RISK REDUCTION FEASIBILITY STUDY
OF SELECTED MODIFICATIONS TO
CRBRP SAFETY SYSTEMS

FINAL REPORT

SAI-84-123-WA

U.S. Nuclear Regulatory Commission
Washington, D.C. 20555

Figure 3-1. CONFIGURATION OF THE DIRECT HEAT REMOVAL SERVICE DURING NORMAL PLANT OPERATION

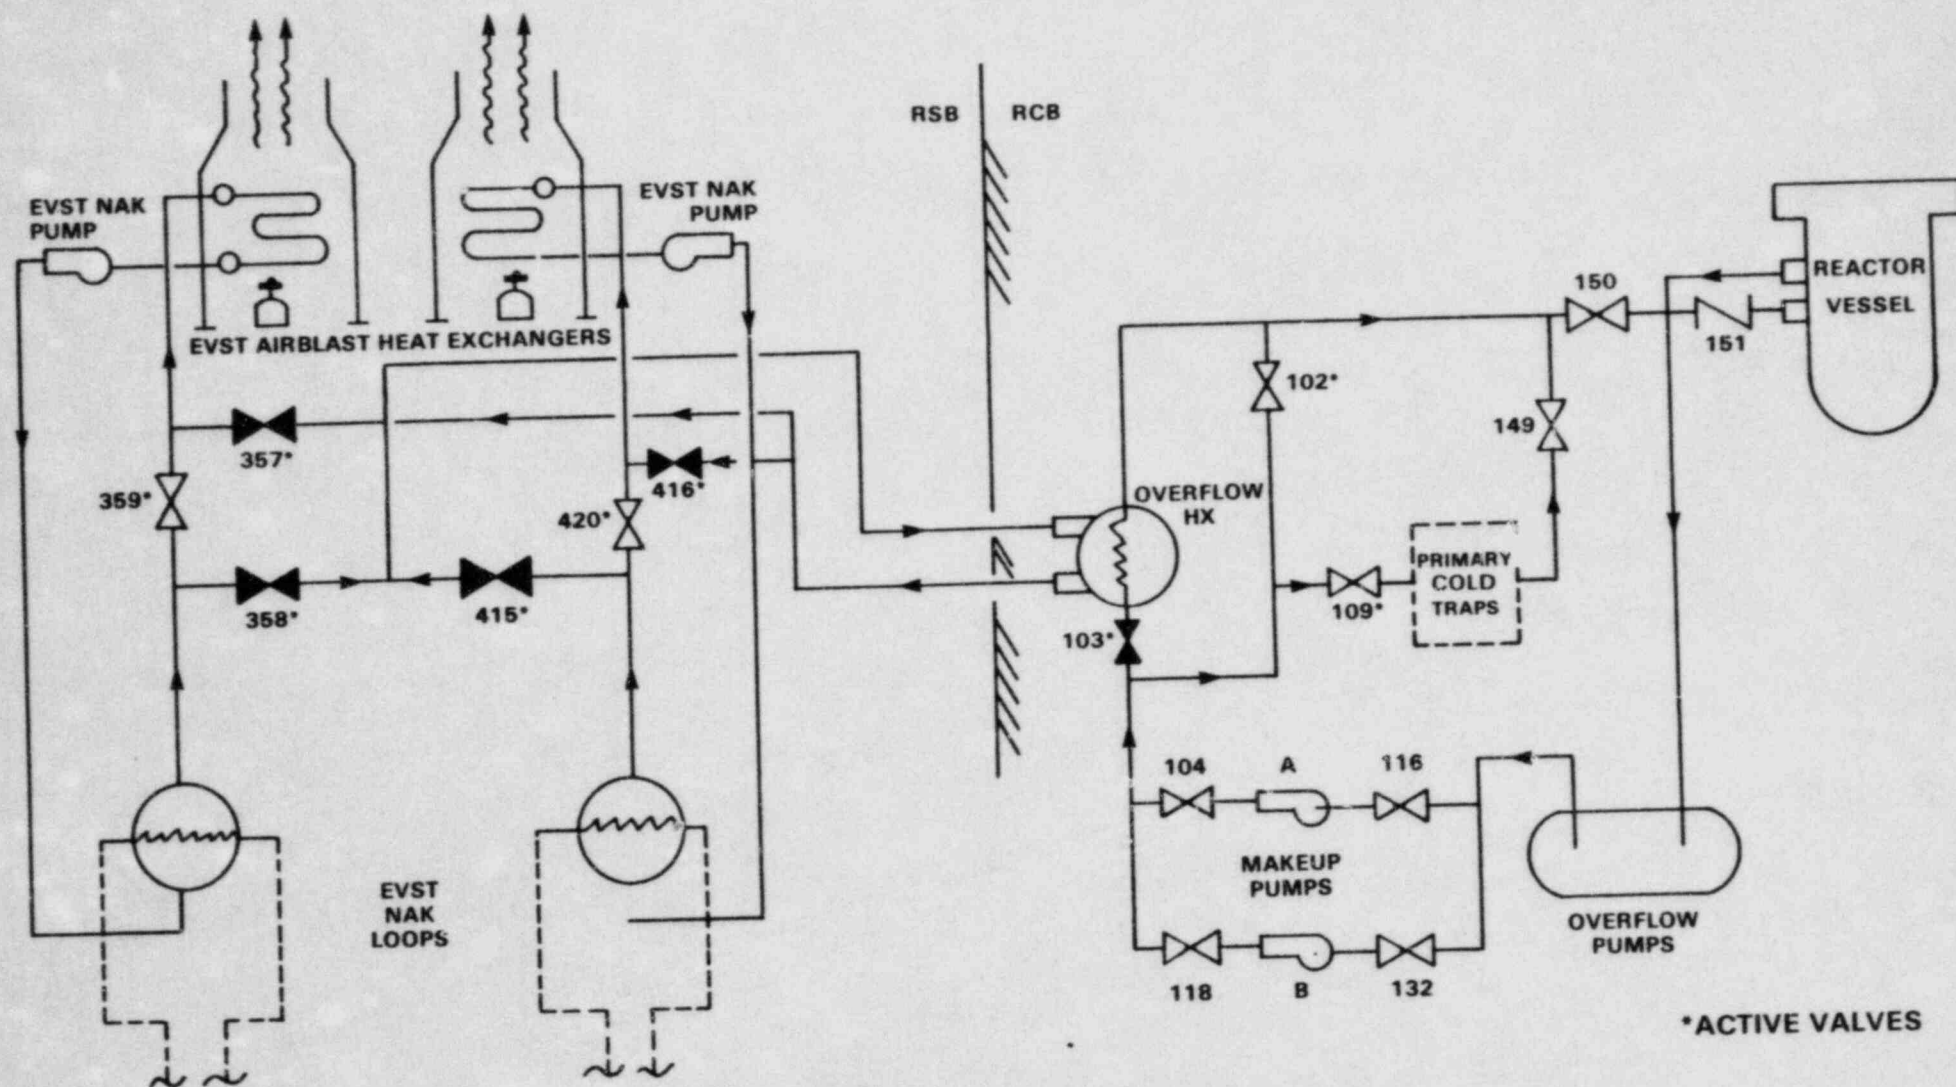
As was discussed in the last section, the importance of the DHRS as a mitigating system is strongly dependent on the frequency of loss of all three main heat transport loops such that DHRS would be required to remove decay heat. Currently there is much uncertainty regarding this value. Irrespective of the probability of the initiator, there are ways to improve the reliability of the DHRS so that even if the probability of loss of all three main heat transport loops is high the overall core melt sequence probability would be small. This is because the DHRS, as currently designed, is vulnerable to a number of "single features."

The first suggestion, which is based on the existing configuration of the DHRS with minimum change of valves and piping, is to make the system redundant. This can be done by incorporating the following changes:

- a. Make the makeup pumps completely redundant by using full-capacity pumps.
- b. Add an SOV on the primary side parallel to SOV 103 so that failure of one SOV to open on demand does not fail the system
- c. Make the secondary side completely redundant by increasing the heat removal capability of each airblast heat exchanger and its associated NaK pump so that the two loops are redundant.

Another way to improve the reliability of the DHRS would be to change the valve configuration such that a single valve failure cannot disable the system. As was mentioned earlier, the major contributors to the failure of the DHRS are failure of one valve on the primary side or any one of six valves on the secondary side to change state upon actuation of the system. If the valve configuration is changed so that no single valve failure can disable the system, all the single element minimal cut sets can be eliminated. Moreover, a modified configuration would make it easier to maintain the system without unduly increasing system unavailability. In fact, with the system subject to so many single failures, it may be impossible to allow maintenance of components while the reactor is at power and still stay within acceptable unavailability bounds.
